Department  
for Transport

# Interim changes to the Guidance on the use of Tactile Paving Surfaces

**August 2015**

Figure 1.1: Treatment of an uncontrolled crossing point at an irregular corner under the existing tactile guidance (left) and under the proposed amendment 1.1 (right).

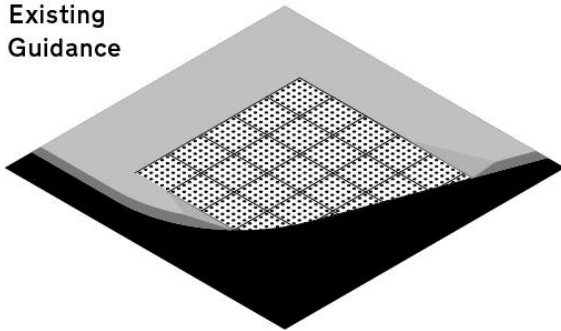
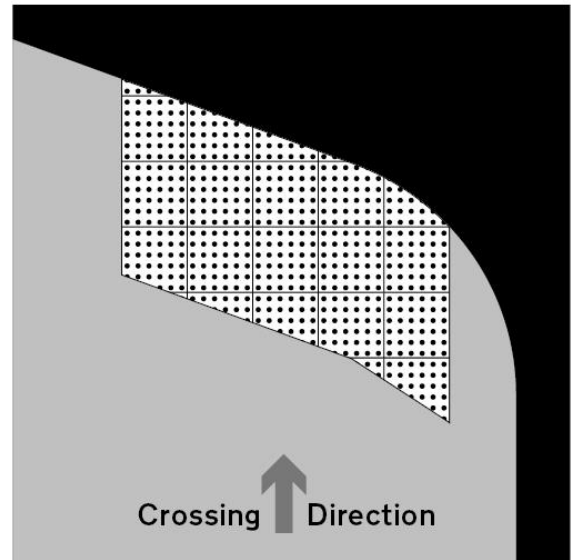
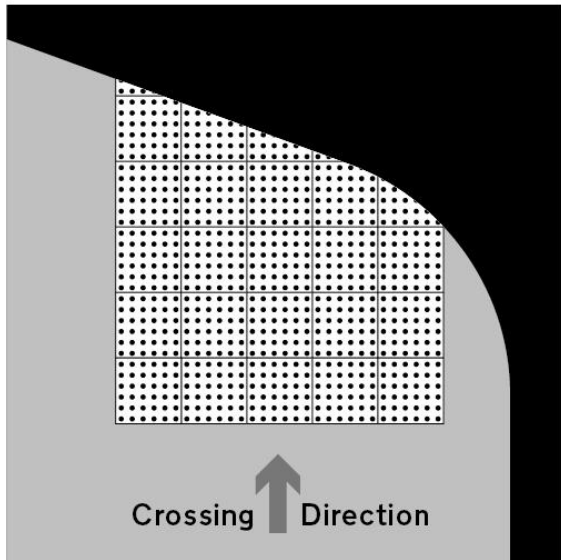
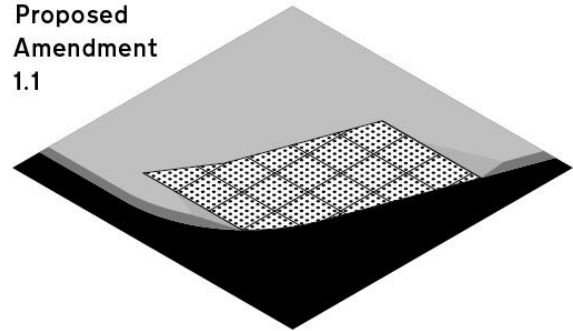
“The back edge (of the section of tactile surface which extends across the dropped kerb) should be at right angles to the direction of crossing (Figure 3 page 29). This may not necessarily be parallel to the kerb.” 1.5.1.2 (p28)

It was acknowledged by workshop participants that the expansive trapezoidal areas of blister surface, created by the strict application of the perpendicular back edge rule at many irregular crossing points, were not providing the accurate orientation information many people with sight impairments need to navigate. It was felt that the increase in accuracy and specificity that would be provided by a smaller, simpler area of blister surface would justify the loss of the information provided by the perpendicular back edge.

The back edge (of a section of tactile surface marking the boundary between the footway and carriageway) should be parallel with the boundary and set back in the direction of crossing by a fixed distance (typically 800 mm or 1200 mm).

This change should not affect the practice of laying the tactile surface so the blisters are aligned parallel to the direction of crossing nor the requirement for the provision of a stem at controlled crossing points 1.5.1.2 (p30).

Figure 1.2: Treatment of an uncontrolled crossing point at an irregular corner under the existing tactile guidance (left) and under proposed amendment 1.2 (right).

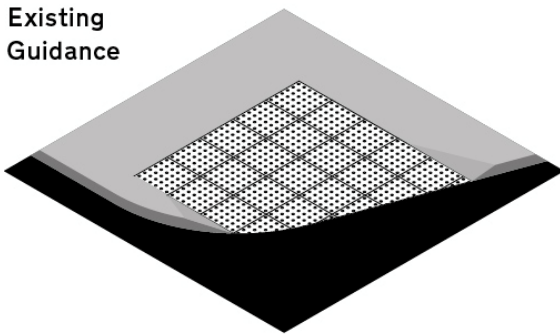
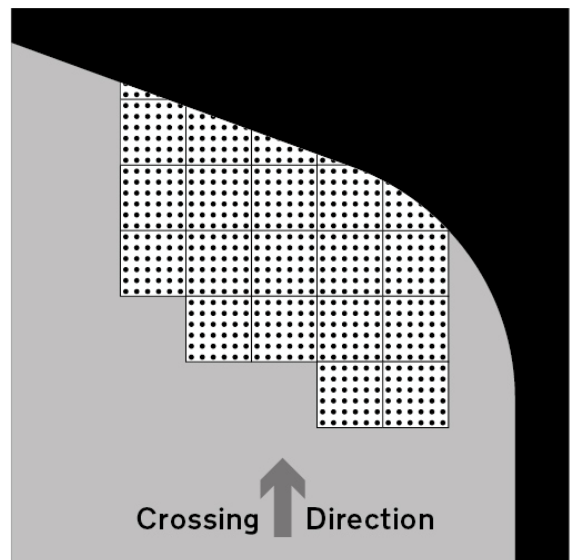
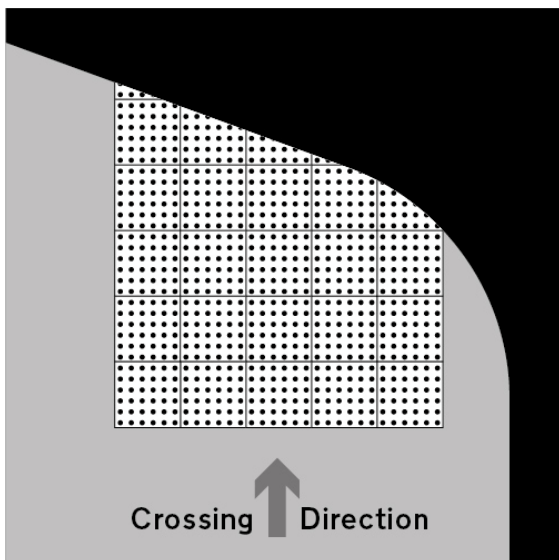
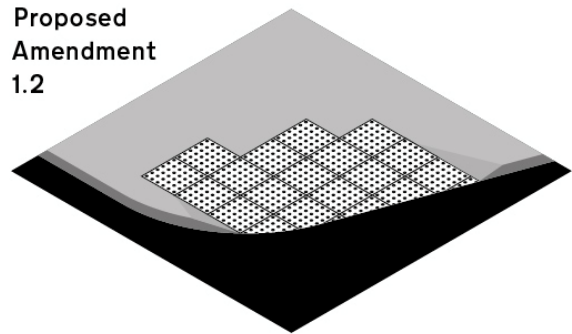
“The back edge (of the section of tactile surface which extends across the dropped kerb) should be at right angles to the direction of crossing (Figure 3 page 29). This may not necessarily be parallel to the kerb.” [1.5.1.2 (p28)]

It was acknowledged by workshop participants that the expansive trapezoidal areas of blister surface, created by the strict application of the perpendicular back edge rule at many irregular crossing points, were not providing the accurate orientation information many people with sight impairments need to navigate. A stepped approach would reduce the requirement for tactile tiles to be cut to match the kerb profile at the back of the installation (as they already are at the front).

The back edge (of a section of tactile surface marking the boundary between the footway and carriageway) should approximate the line of the boundary using a stepped approach with the appropriate minimum distance (typically 800 mm or 1200 mm) maintained but in some places increasing so that the back edge of each individual tile remains perpendicular to the direction of crossing.

This change should not affect the practice of laying the tactile surface so the blisters are aligned parallel to the direction of crossing nor the requirement for the provision of a stem at controlled crossing points 1.5.1.2 (p30).

Figure 2.1: Images showing different combinations of colours of tactile paving and surrounding paving with their measured contrast ratios.

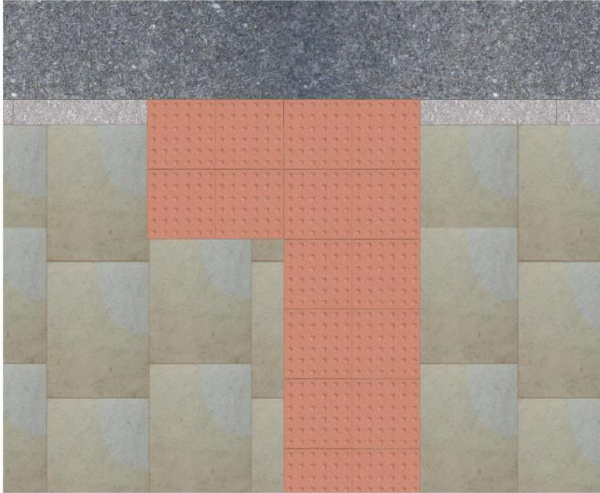
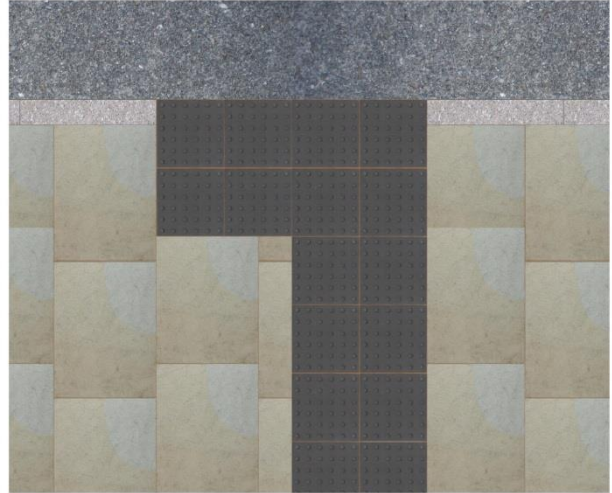
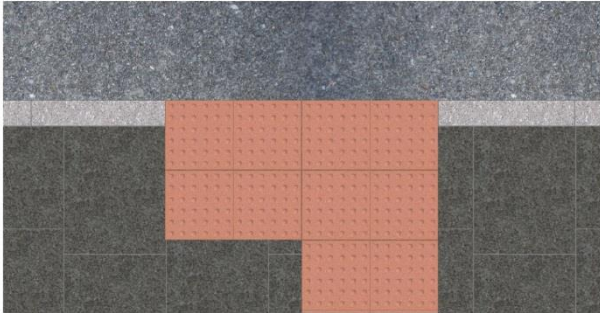
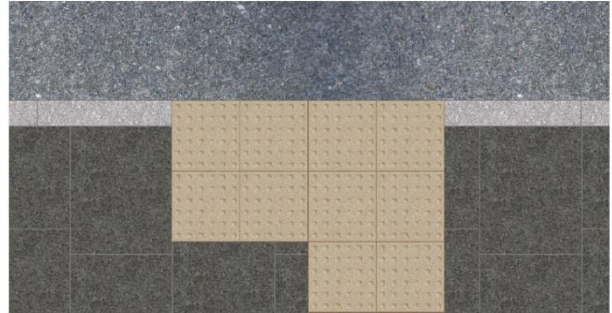
“The red blister surface should be used at controlled crossings only.[...] It is best to avoid using any other red material in the vicinity of a controlled crossing. Where this is unavoidable it will be necessary to provide a contrasting border around the blister surface contrasting in colour and tone. A border 150mm wide should provide sufficient contrast. Where there are conservation considerations an alternative colour for the tactile surface may be appropriate (see 1.5.6).” 1.5.1.1 (p28)

“Where the blister surface is provided at crossing points in conservation areas or in the vicinity of a listed building, some relaxation of the colour requirements may be acceptable. In these limited circumstances only, the tactile surface may be provided in a colour which is in keeping with the surrounding material.” 1.5.6 (p51)

Workshop participants felt that for the majority of street users with low vision colour contrast provided more assistance than the presence of a specific colour (particularly a colour so close in tone to common paving materials such as Yorkstone). Adoption of a specified minimum contrast ratio should ensure consistency in the presence of this contrast whilst providing designers freedom to design in sympathy to local context.

The tactile surface used to indicate the presence of a controlled crossing should provide a contrast ratio of at least 50% to the surrounding paving in both wet and dry daylight conditions and when illuminated by the adjacent street lighting at night.

Figure 3.1: Proposed deployment of tactile surface(s) in level surface contexts

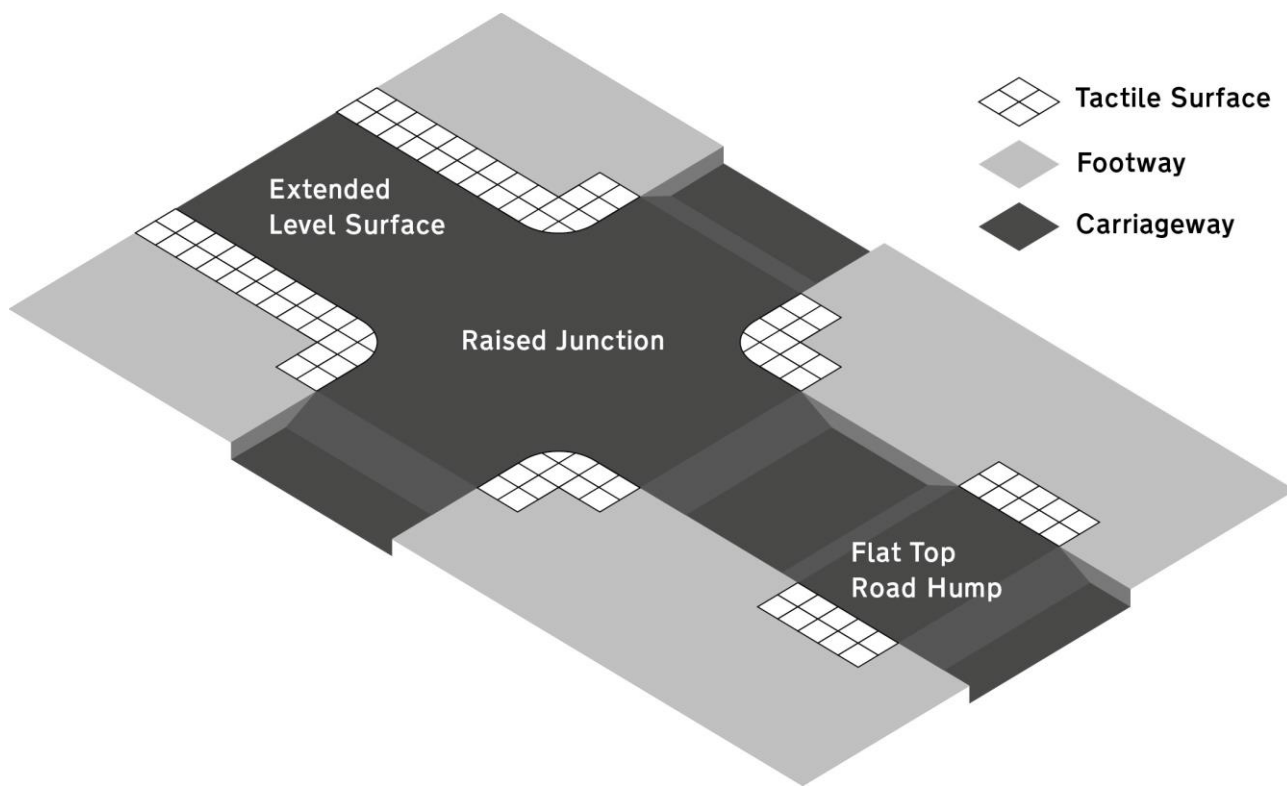
“Where an extensive area of the carriageway has been raised then it will not be appropriate to install the tactile surface along the full length. In those circumstances the tactile surface should be limited to the ‘crossing’ area (Figure 15 page 49), and the remaining raised carriageway either side of the tactile surface should maintain a level difference with the footway of at least 25mm high or have a continuous physical barrier, for example, planters, railings” 1.5.5.1 (p48) [...] “Where the carriageway has been raised to the level of the footway around an entire junction, it is essential that visually impaired pedestrians are kept away from the radius by the use of continuous physical barriers, for example, guard railings (Figure 17 page 50).” 1.5.5.3 (p48)

Workshop participants agreed that there needed to be a simple, unambiguous rule to prevent the appearance of un-delineated level surfaces (for example where designers implemented the raised junction treatment described but omitted the guard railings). Research has indicated that 60mm is the minimum level change that can be reliably detected by people with sight impairments in the absence of tactile paving whilst 800mm is the minimum depth of tactile paving that can be reliably detected.

Wherever there is no level change between carriageway and footway, or a level change of less than 60mm, the boundary between footway and carriageway should be delineated with a tactile surface of at least 800mm in depth. This rule should apply to any continuous barrier-free surface occupied by pedestrians and vehicles be that a flat top road hump, a raised side road or junction, or an extended level surface area.
